## **Addendum 2: Global technical regulation No. 2**

**Measurement procedure for two-wheeled motorcycles equipped with a positive or compression ignition engine with regard to the emission of gaseous pollutants, CO2 emissions and fuel consumption**

## **Amendment 3**

Established in the Global Registry on 27 June 2013

Paragraph 1., Figure A13-1, amend to read:

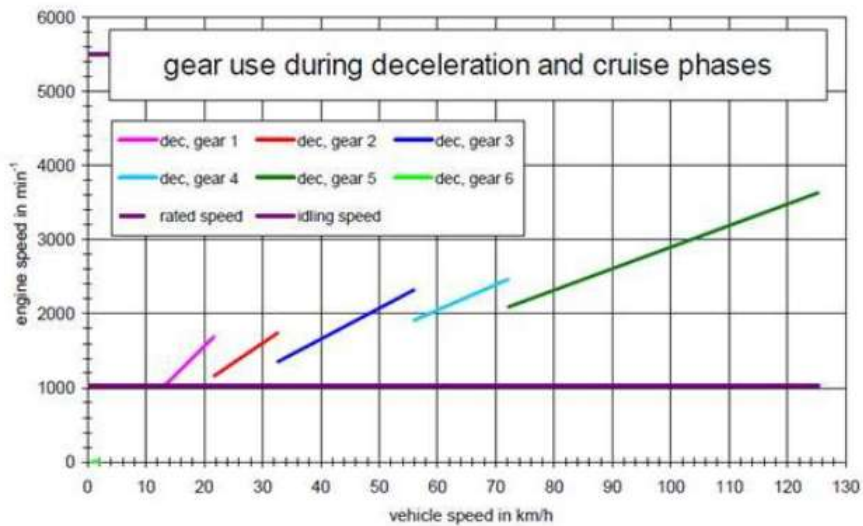
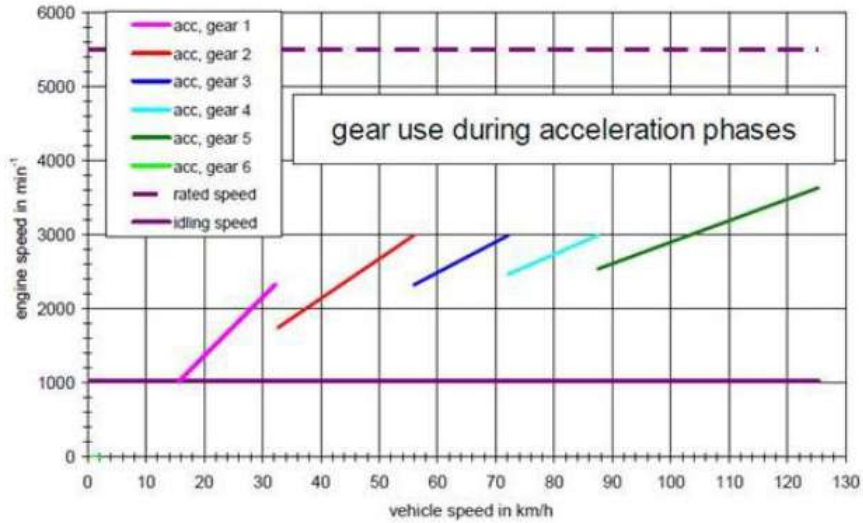
Annex 13,
